APPLICATION NO.	FILING DATE	FIRST NAMED INVENTOR	ATTORNEY DOCKET NO.	CONFIRMATION NO.
10/731,210	12/09/2003	B. Thomas Barker	4002-	4618

Office Action Summary

DETAILED ACTION

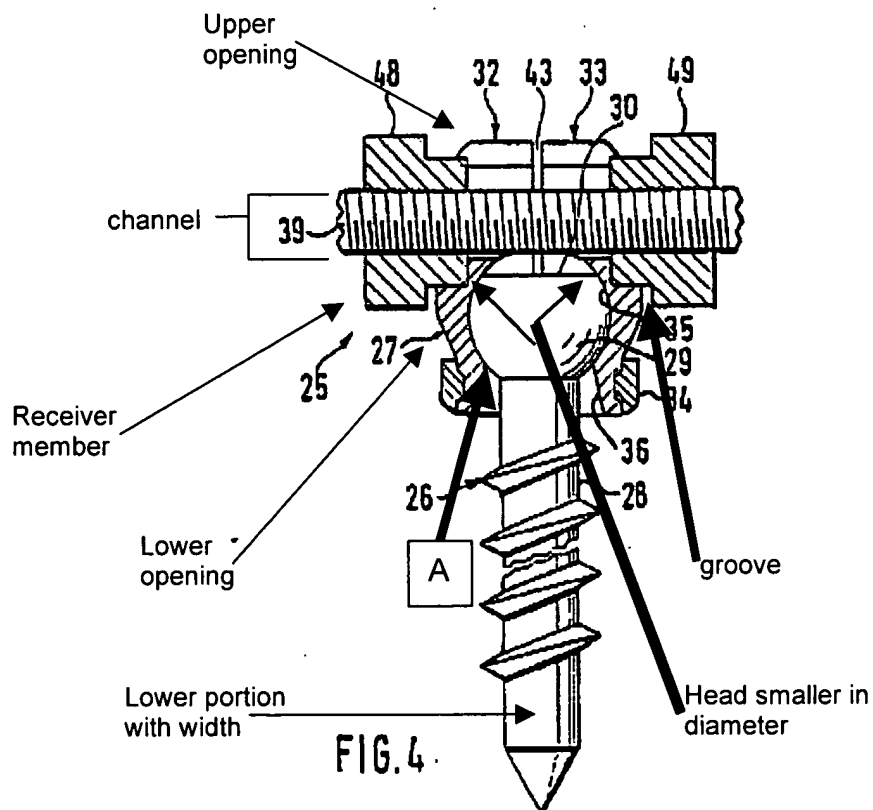
The drawings are objected to under 37 CFR 1.83(a) because they fail to show item 91, known as the gap, as described in the specification. Any structural detail that is essential for a proper understanding of the disclosed invention should be shown in the drawing. MPEP § 608.02(d). Corrected drawing sheets in compliance with 37 CFR 1.121(d) are required in reply to the Office action to avoid abandonment of the application. Any amended replacement drawing sheet should include all of the figures appearing on the immediate prior version of the sheet, even if only one figure is being amended. The figure or figure number of an amended drawing should not be labeled as "amended." If a drawing figure is to be canceled, the appropriate figure must be removed from the replacement sheet, and where necessary, the remaining figures must be renumbered and appropriate changes made to the brief description of the several views of the drawings for consistency. Additional replacement sheets may be necessary to show the renumbering of the remaining figures. Each drawing sheet submitted after the filing date of an application must be labeled in the top margin as either "Replacement Sheet" or "New Sheet" pursuant to 37 CFR 1.121(d). If the changes are not accepted by the examiner, the applicant will be notified and informed of any required corrective action in the next Office action. The objection to the drawings will not be held in abeyance.

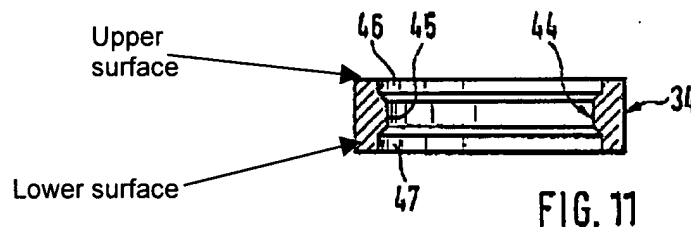
Claims 1, 2, 3, 20-23, 29-30, 36-38, 39-43 are rejected under 35 U.S.C. 102(b) as being anticipated by Harms et al. (U.S. Patent 4,946,458). Harms et al. discloses a bone anchor assembly having a receiving member, having an upper opening, a lower opening, a channel configured to receive an elongated member, and a groove around the lower portion of the receiving member. See FIG. 4 below.

Harms et al. also discloses a bone engaging anchor (e.g. a bone screw) that has a lower portion having a width (see Fig. 4), a head (29) that has a width smaller than the lower opening portion (see Fig. 4), a retaining member with a diameter smaller than the head and positioned below the head (see item A, in Fig. 4 above) and that is partially housed in the groove of the receiver member (see item labeled "groove" above). Harms et al. further shows a compression member with two branches (items 48 and 49 above) capable of securing an elongated member (e.g. a rod--39), and a crown member that can be considered beveled and concave that defines a hole through the apparatus. (See. Fig. 9). Being beveled and concave implies that a hole is present to acquire that shape.

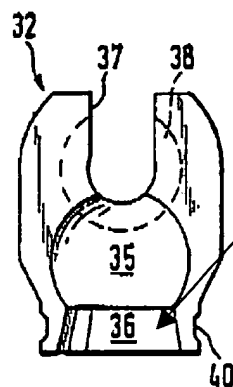
Item 36 is beneath crown member 34. This figure shows the rounded, beveled shape that creates a hole. Since the crown surrounds item 36, it must have the same shape.
